# **Intel<sup>®</sup> Pentium<sup>®</sup> II Xeon<sup>™</sup> Processor Specification Update**

Release Date: December 2000

Order Number: 243776-027

**Figure 1. An Example of Microcontroller Driven Thermal Management**

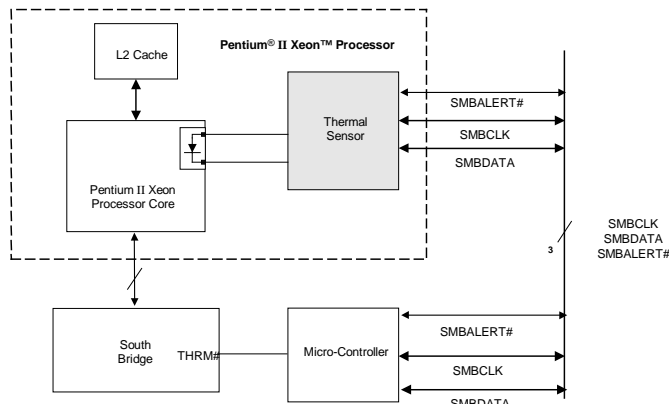
### D30. Thermal Sensor May Assert SMBALERT# Incorrectly

**Problem:** The Pentium II Xeon processor has a thermal sensor that monitors the processor core's temperature. The thermal sensor asserts SMBALERT# if the processor temperature exceeds the temperature limits set in the Alarm Threshold Registers ( $T_{HIGH}$ ,  $T_{LOW}$ ). It also sets the corresponding Status Register bits to identify the cause of the interrupt. Figure 1 gives one example of the how the SMBALERT# signal could be used in a system.

Under the conditions described below, the thermal sensor incorrectly generates the SMBALERT# interrupt. All of the following conditions must be met to trigger a false interrupt:

**Workaround:** Three different (mutually exclusive) workarounds are possible:

1. Before servicing an interrupt from the thermal sensor, read and compare the processor thermal reading with the threshold limits ( $T_{HIGH}$  or  $T_{LOW}$ ). Figures 2 and 3 provide basic flowcharts for the implementation of this workaround in an interrupt driven system.
2. If the firmware implemented polls the Status Register only, then before taking any action, re-read the temperature register and do a comparison with the alarm threshold limits ( $T_{HIGH}$  or  $T_{LOW}$ ) to determine if the value is actually still within the temperature window.
3. Use a temperature polling scheme to monitor the processor temperature
